GJS Plot F, Manchester

Tower F2 - Podium Design | 26.04.2024

F2-SHP-A180-RP-XX-B5D803 | P04

Background to the report

Updated Proposal - Decorative Screens

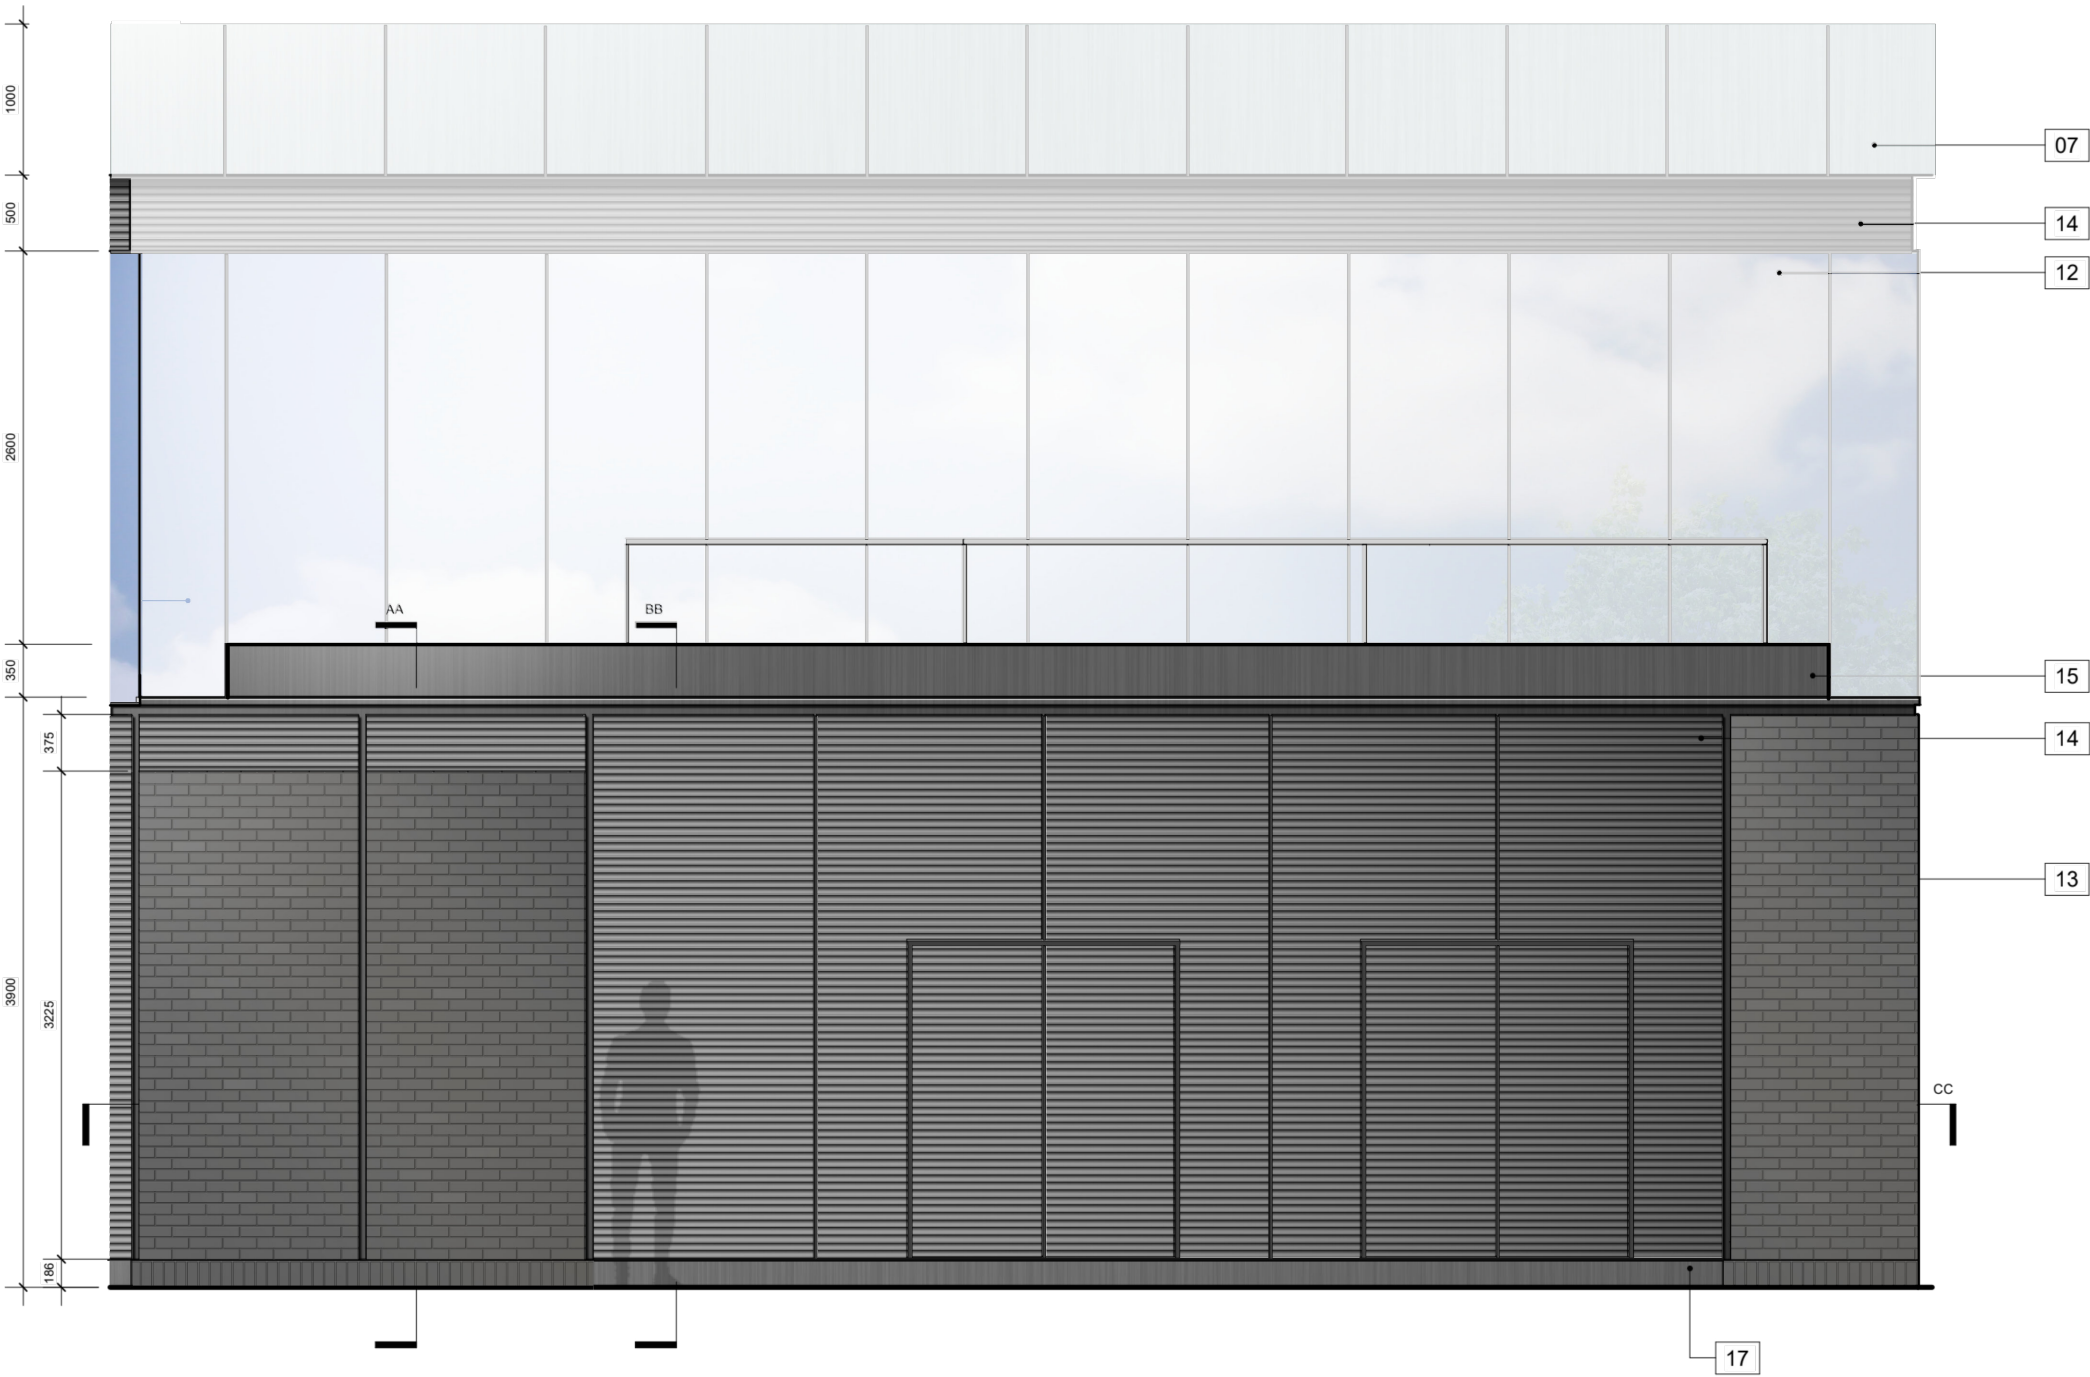
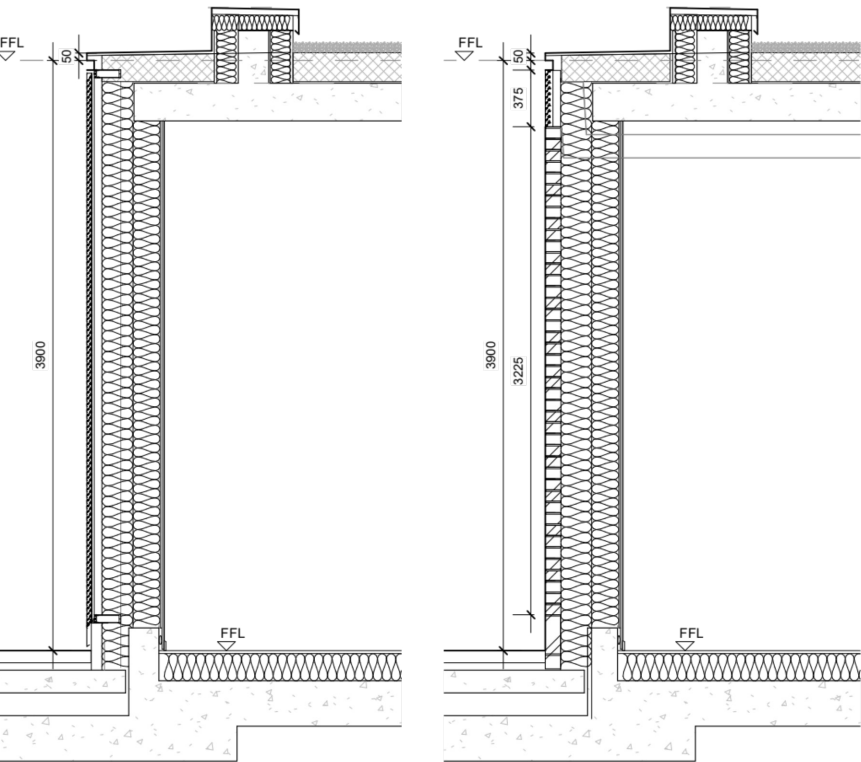
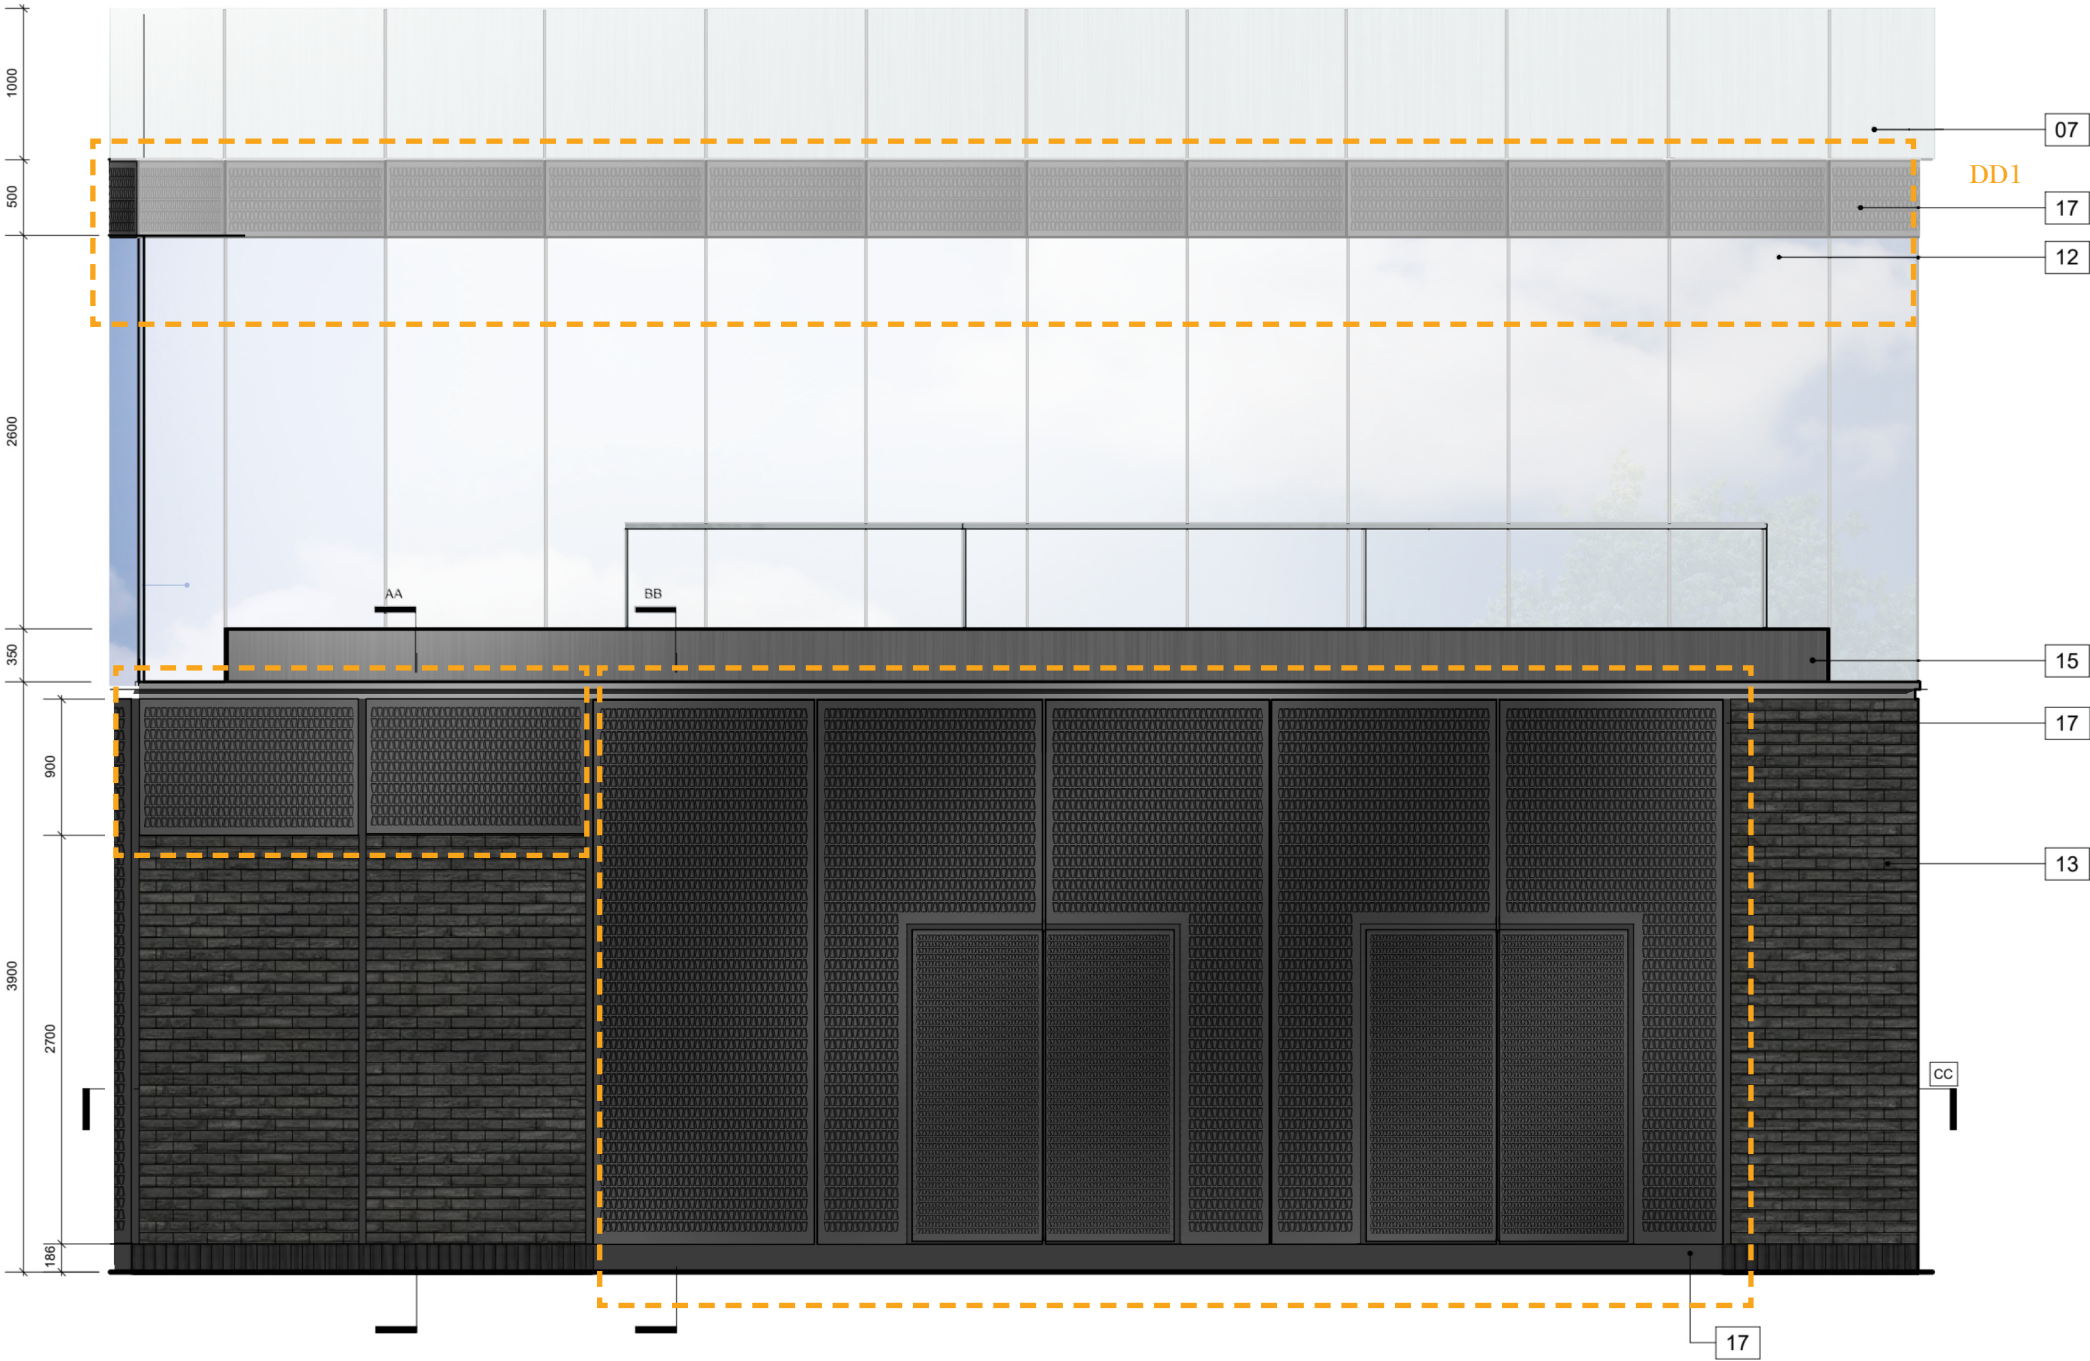
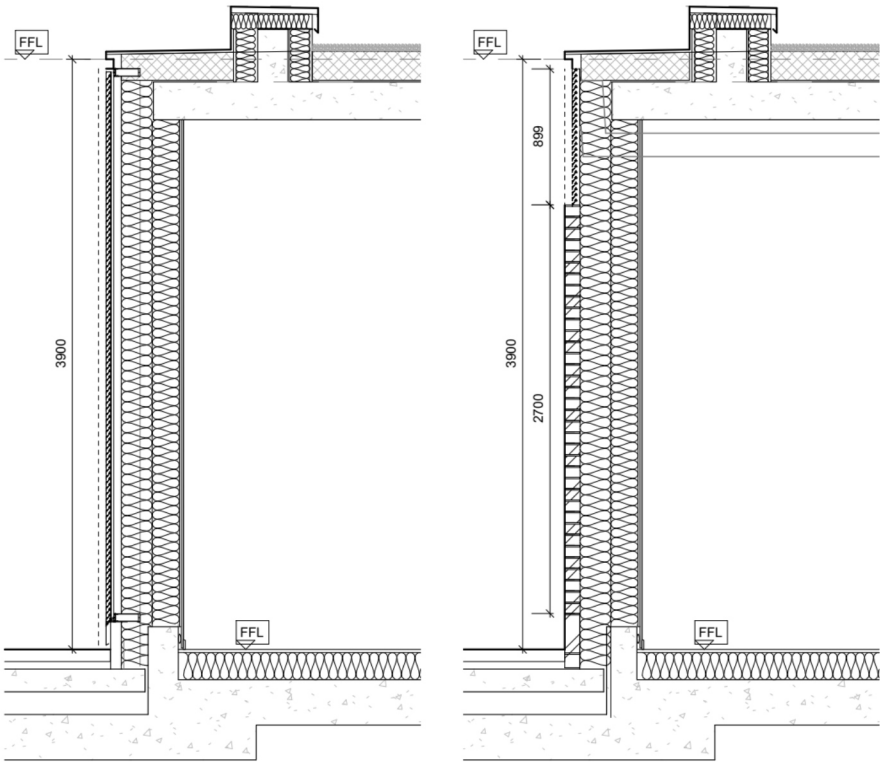
Further to the above application, I note that there are large areas of louvres proposed for the ground floor elevations where there are plant and waste storage rooms. As these areas front onto pedestrian thoroughfares and will be highly visible, please would you look at using anodised aluminium decorative screening (eg to match the purge vents on the floors above) instead of, or to screen, the large areas of louvres.

The decorative screens are proposed in a dark anodised finish. Behind the screens, where active ventilation connections are required dark louvres finished in black PPC are proposed. Where active ventilation connections are not required a solid aluminium blanking panel will be used finished in black PPC.
